143.3.2 Envelope Header format

Figure 143-11 – Mapping of Envelope Header fields into two xMII transfers

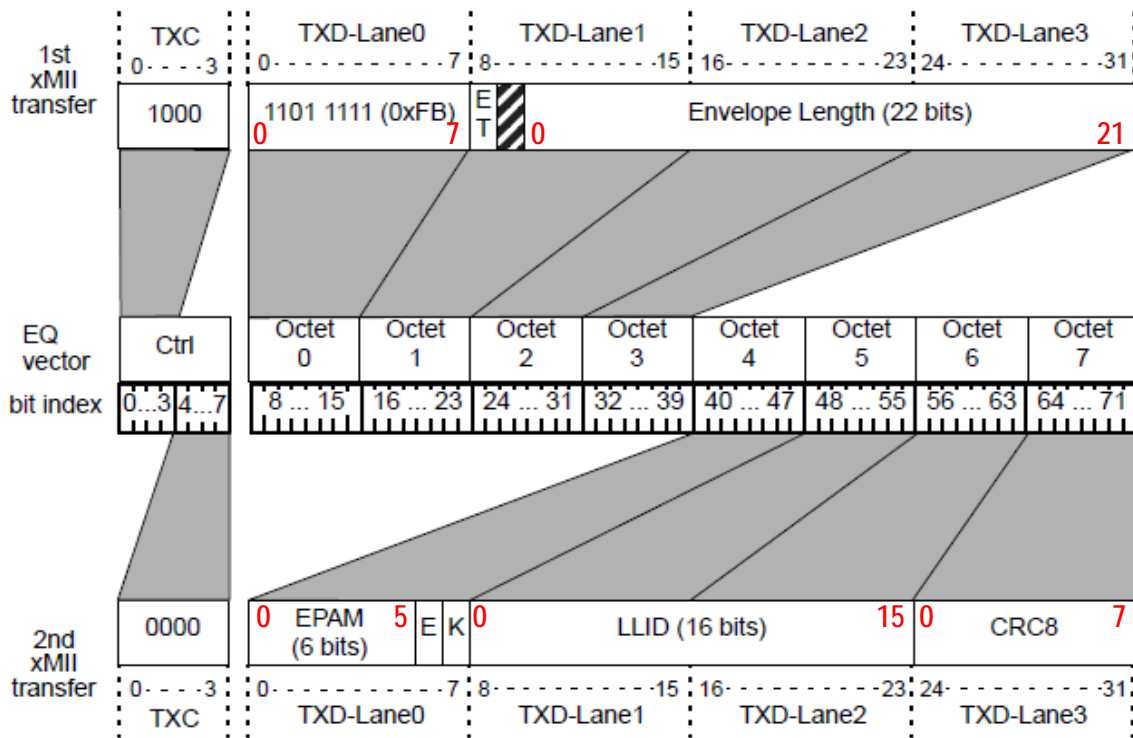
Each envelope initiated by the MCRS begins with a 72-bit envelope header. The envelope header includes a Start Control Code, an EnvType flag bit, a 22-bit Envelope Length field, an Envelope Position Alignment Marker (EPAM) field, two bits (E and ~~SK~~) reserved for encryption purposes, an LLID field, and an 8-bit cyclic redundancy check (CRC8). ~~The envelope length represents the number of EQ in the envelope.~~ When the xMII is 36-bits wide the transmission envelope header, as illustrated in Figure 143–11, includes two successive transfers over the xMII. Each 36-bit transfer includes four control bits followed by 32 information bits.

Octets within each envelope header field are transmitted from least significant to most significant. Bits within each octet are transmitted from LSB to MSB. An EQ contains eight octets of information so the length of the envelope header is equals one EQ. ~~The EPAM is used by the receiving MCRS to remove any timing skew that may have occurred during the transmission of the envelope from the source MCRS to the destination MCRS. The LLID field is set to the value of the LLID of the MAC associated with the data in the envelope. The CRC8 field is used for error detection within the header. There is one reserved bit (EQ bit 17) and it is set to zero at the transmitter and its value is ignored at the received except for the purposes of calculating the CRC8.~~ The envelope header shall use the format shown in Table 143–3.
